REQUEST FOR COUNCIL ACTION

AGENDA SECTION: PUBLIC HEARINGS	ORIGINATING DEPT: PLANNING	ITEM NO.
ITEM DESCRIPTION: Land Subdivision Permit (Preliminary Plat) #03-10 to be known as Badger Village Townhomes by Circle 22 Investors, LLC. The Applicant is proposing to resubdivide Lots 1 & 2, Block 2 Badger Ridge Fourth Subdivision into 37 lots for single family attached dwellings. The Plat also proposes to dedicate one new public roadway. The property is located west of Superior Drive NW, east of Kenosha Drive NW and north of Monroe Drive NW.		PREPARED BY: Brent Svenby, Planner

Type III, Phase II, Land Subdivision Permit #03-10 (Preliminary

Plat) to be known as Badger Village Townhomes

BADGER VILLAGE TOWNHOMES

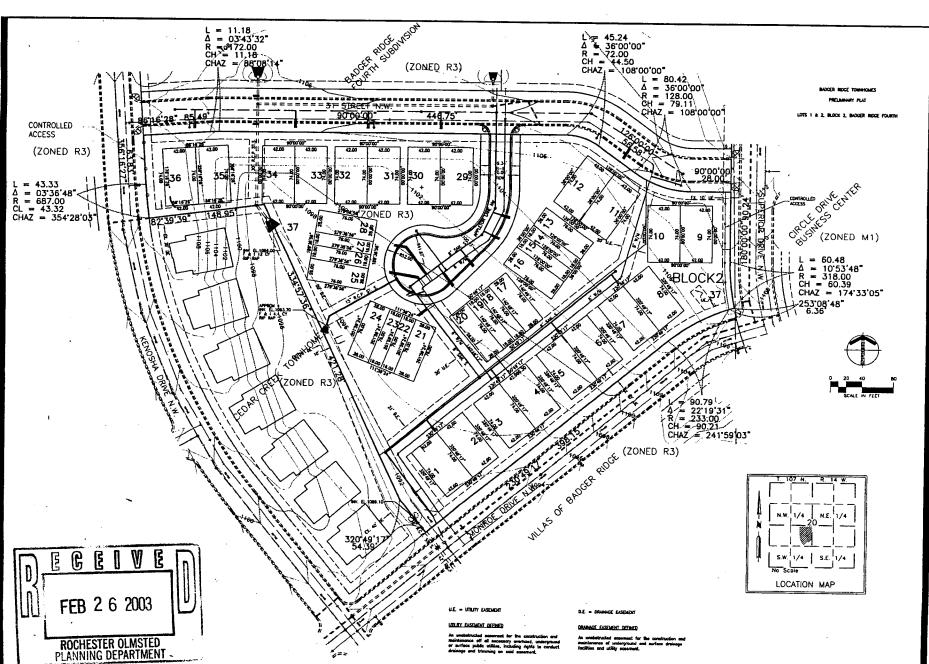
- 1. The cul-de-sac associated with this plan is indicated as less than 96 feet in diameter and shall be posted "No Parking" along the cul-de-sac.
- 2. The plat shall be labeled as Block 1 instead of Block 2.

The static water pressure within the area ranges from 72 to 83 PSI. The water system layout depicted is not the correct construction plans approved for Badger Ridge 4th Subdivision. Final utility plans will need to be approved prior to the submittal of the final plat.

- 1. Static water pressures within this area will range from 72 to 83 PSI.
- 2. The final construction plans for Badger Ridge Fourth Subdivision, which incorporates this area have been approved. The water system layout depicted in this submittal is incorrect and should not be used.

Cul-de-sacs less than 96 feet in diameter shall be marked "No Parking" along the cul-de-sac. The cul-de-sac associated with this plan is indicated as less then 96 feet and therefore shall be marked "No Parking".
